## **PARK FOREST ESTATES SUBDIVISION, SEVENTH ADDITION, RESUBDIVISION OF LOT 16**

Engineering Comments: FINAL PLAT COMMENTS (should be addressed prior to submitting the FINAL PLAT for review and/or signature by the City Engineer):

APPLICATION NUMBER 4 DATE August 16, 2018  
 APPLICANT Park Forest Estates Subdivision, Seventh Addition, Resubdivision of Lot 16  
 REQUEST Subdivision

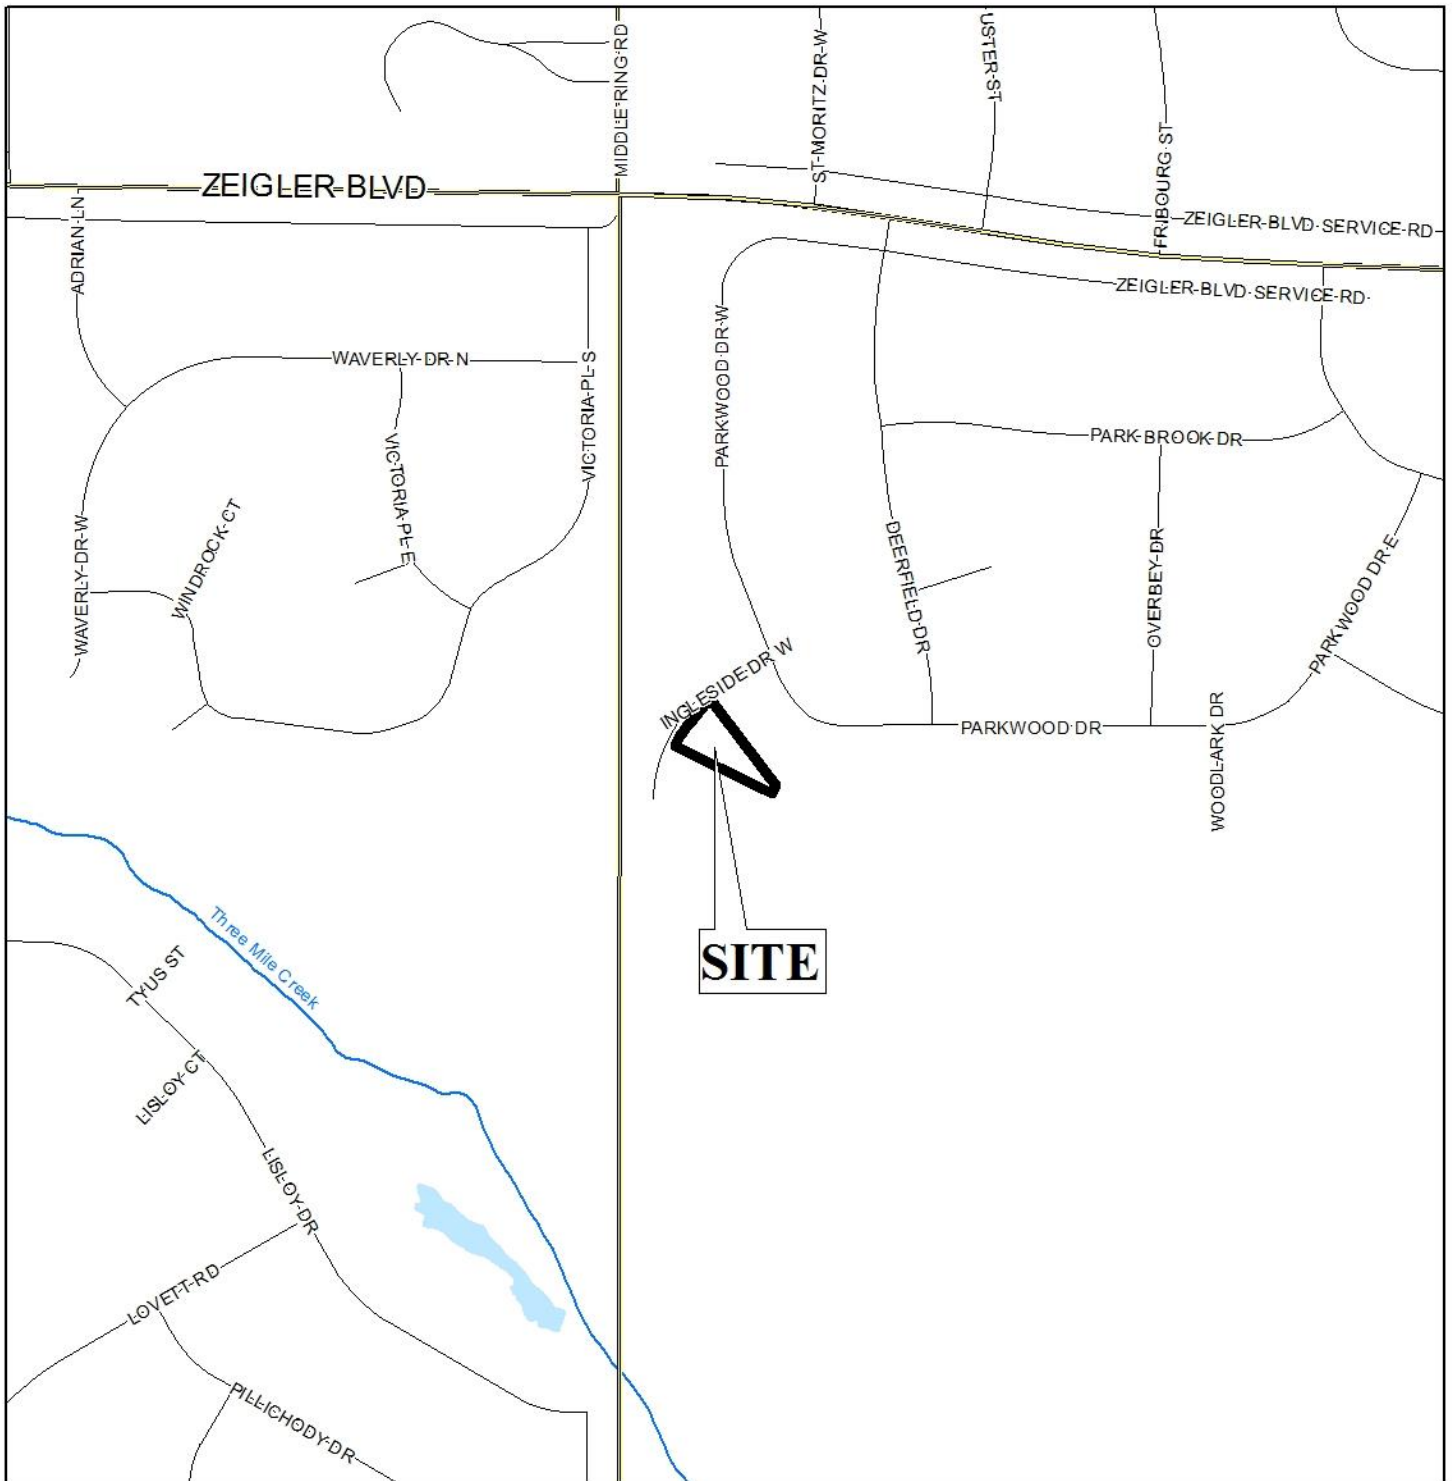
The lot was originally approved by the Planning Commission at its January 2, 1969 meeting with a 30 foot front minimum building setback line. The property owner constructed an addition on the front of the existing dwelling that is 25.2 feet from the front property line within the recorded setback, thus the current Subdivision application to request the recorded 30 foot setback be reduced to 25 feet. It should also be noted that the site has a Variance application on the Board of Zoning Adjustment's September 10, 2018 agenda to get approval for a garage that was built 0.3 feet into the required 8 foot side yard setback.

- 1) retention of the 25' minimum building setback line on the Final Plat;
- 2) retention of the lot size in square feet and acres;
- 3) placement of a note on the Final Plat stating the lot is limited to the existing curb cuts with changes in size, location and design to be approved by Traffic Engineering, and conform to AASHTO standards;

# DETAIL SITE PLAN

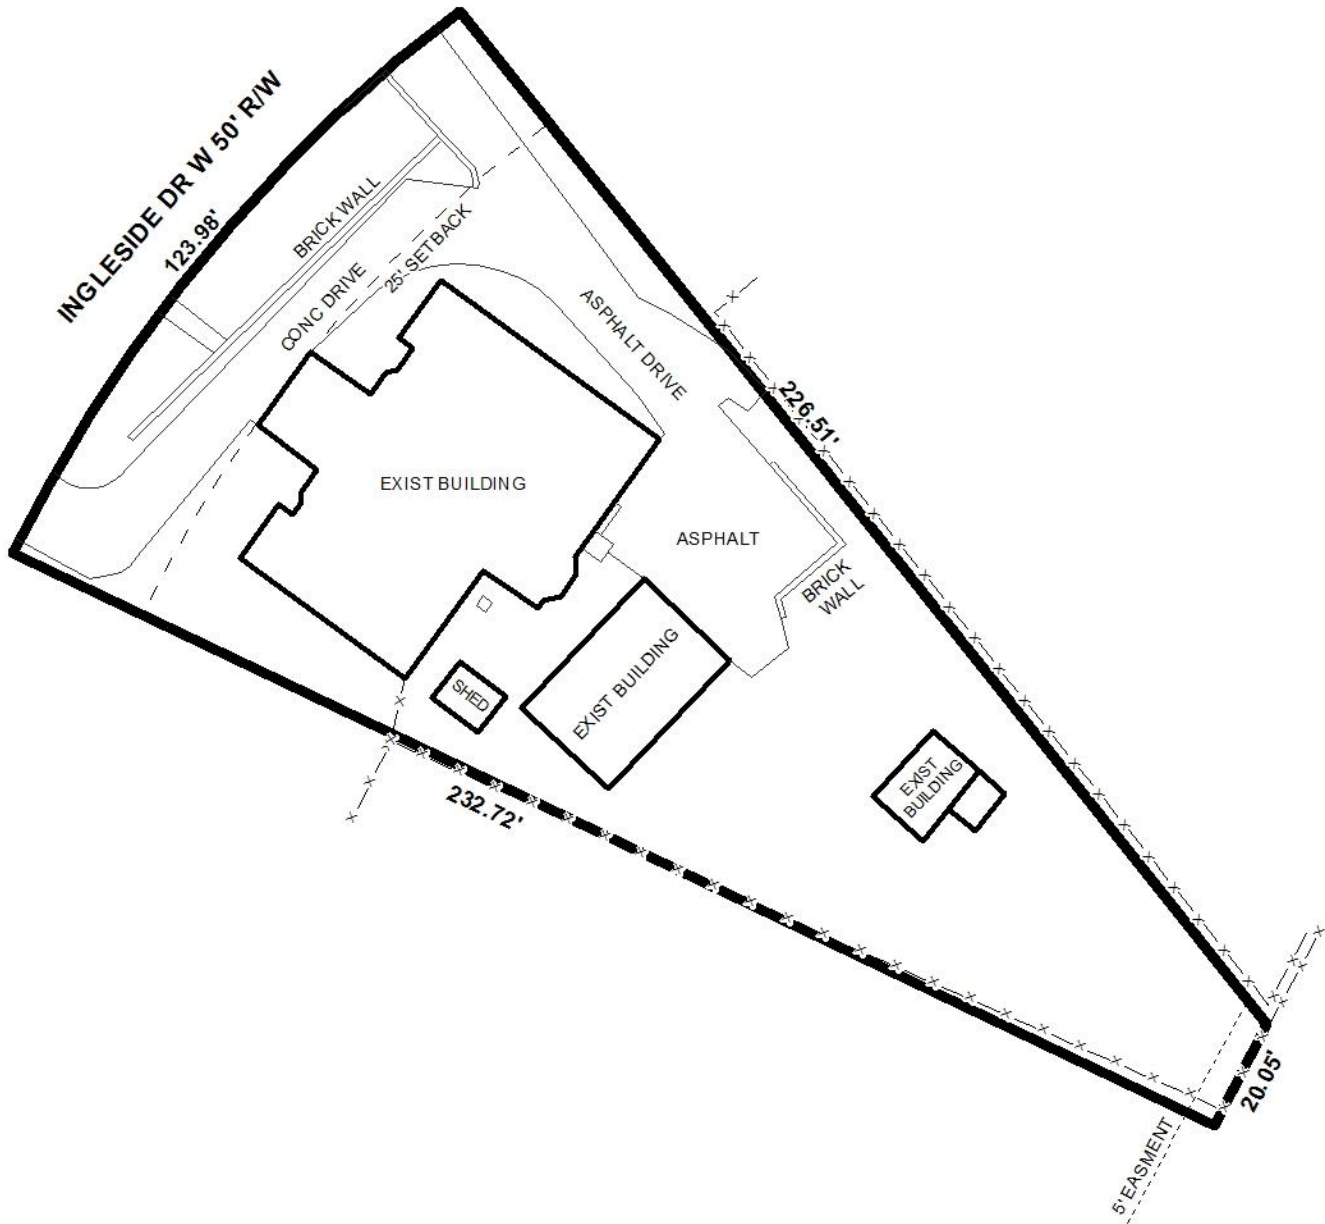
- A. Provide all of the required information on the SUBDIVISION PLAT (i.e. signature blocks, signatures, certification statements, written legal description, required notes, legend, scale, bearings and distances) that is required by the current Alabama State Board of Licensure for Professional Engineers and Land Surveyors.

- B. Show and label each and every Right-Of-Way and easement.
- C. Provide the Surveyor's, Owner's (notarized), Planning Commission, and Traffic Engineering signatures.

- D. Add a note to the SUBDIVISION PLAT stating that a Land Disturbance permit will be required for any land disturbing activity in accordance with Mobile City Code, Chapter 17, Storm Water Management and Flood Control; the City of Mobile, Alabama Flood Plain Management Plan (1984); and, the Rules For Erosion and Sedimentation Control and Storm Water Runoff Control.

- E. Add a note to the Plat stating that the approval of all applicable federal, state, and local agencies (including all storm water runoff, wetland and floodplain requirements) will be required prior to the issuance of a Land Disturbance permit.

- F. Add a note that sidewalk is required to be constructed, and/or repaired, along the frontage of each lot, or parcel, at time of new development or construction, unless a sidewalk waiver is approved.

- G. Add a note to the plat stating that all easements shall remain in effect until vacated through the proper Vacation process.
- H. Provide a copy of the FINAL SUBDIVISION PLAT to the Engineering Dept. for review. No signatures are required on this drawing.

Traffic Engineering Comments: Lot is limited to its existing curb cuts with any changes in size, location and design to be approved by Traffic Engineering and conform to AASHTO standards.

As a means of access management, a note should be placed on the Final Plat, if approved, stating the lot is limited to its existing curb cuts with changes in size, location and design to be approved by Traffic Engineering, and conform to AASHTO standards.
